Corporation of the Town of Erin  
5684 Trafalgar Rd.  
Hillsburgh, ON  
N0B 1Z0

Attn: Ms. Tanjot Bal, Senior Planner

**Re: Response to 2<sup>nd</sup> Submission Comments  
Traffic Impact Study Updated July 28<sup>th</sup>, 2022  
Hillsburgh Heights Inc.  
Proposed Residential Subdivision  
5916 Trafalgar Road North  
Town of Erin  
Town File No. 23T-21002, OP21-01 & Z21-09  
Our File No. W21081**

**PRELIMINARY GRADING PLAN**

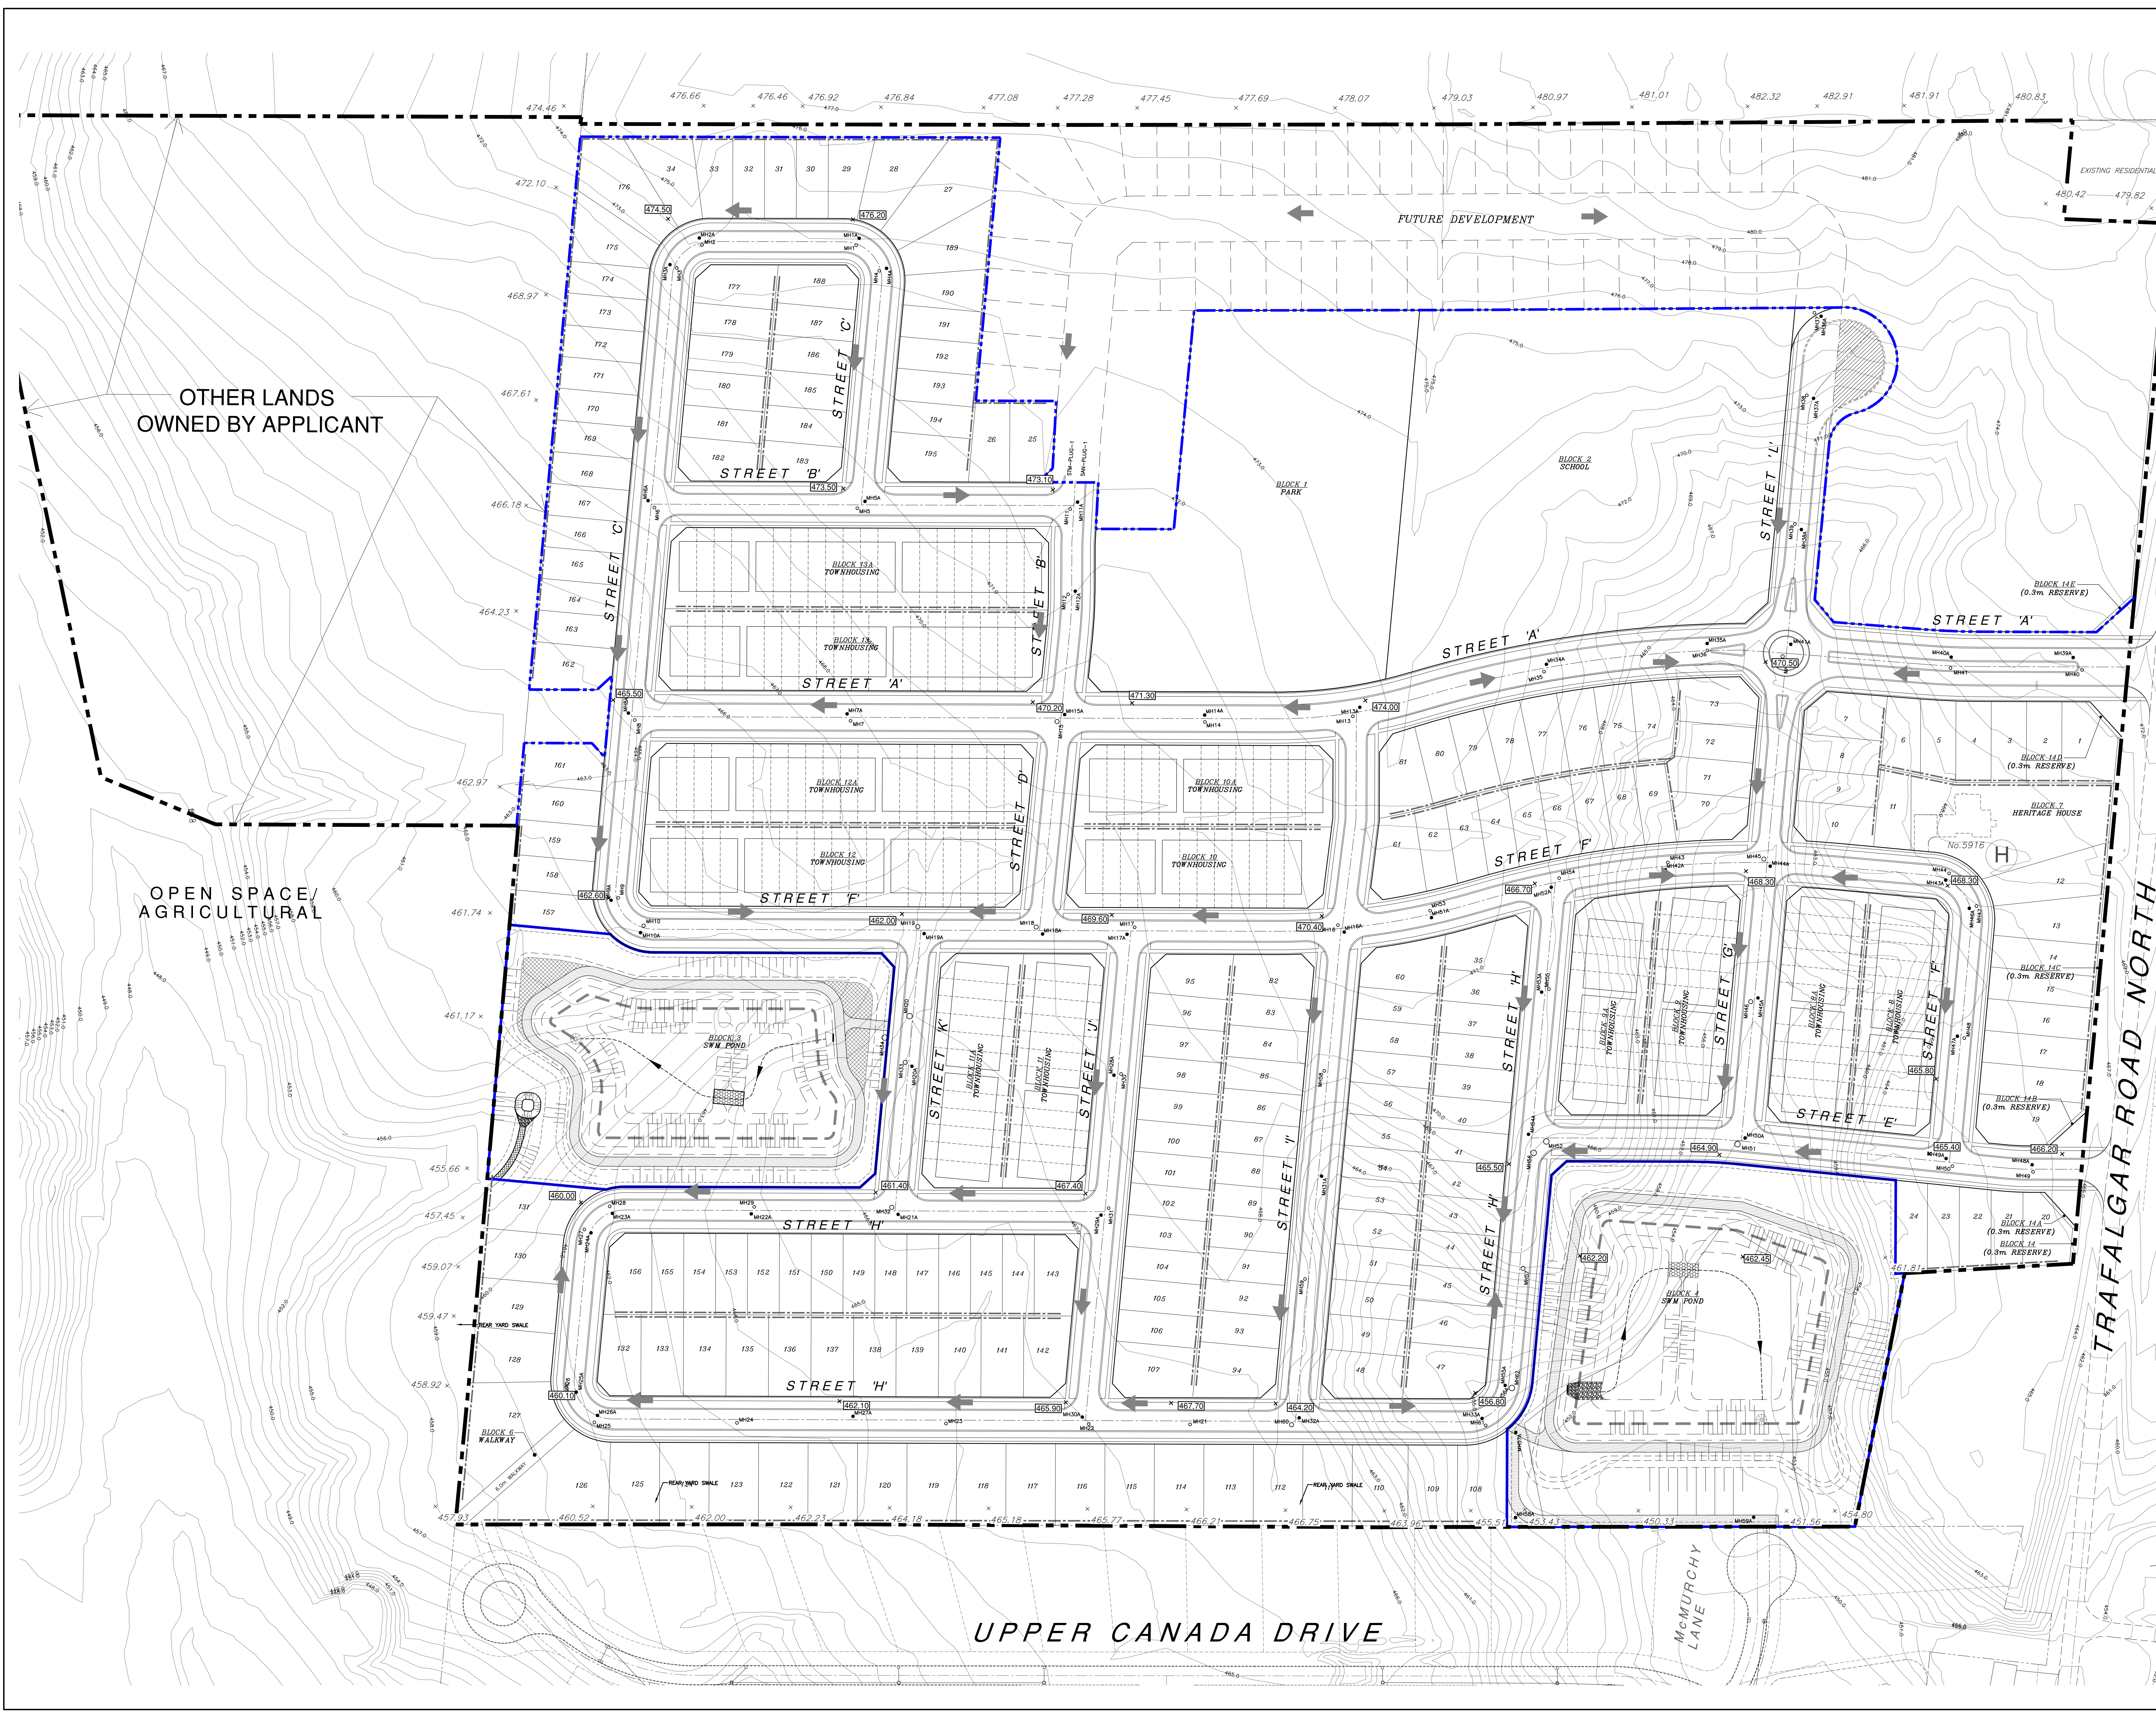
*The report does not provide specific rationale why a road connection to McMurchy Lane cannot be implemented rather than introducing a new (Street 'E') connection to Wellington Road 24.*

As discussed at our meeting on January 11<sup>th</sup> 2023 and as mentioned in the Traffic Impact Study Update and in the Response to Peer Review Comments Letter, a road connection with McMurchy Lane is not feasible due to constraints in grading. A SWM pond is also proposed at this location. To provide a better understanding of the constraints due to grading, the Preliminary Grading Plan (Drawing GR-1) provides the existing surface elevations on McMurchy Lane and within the subdivision.
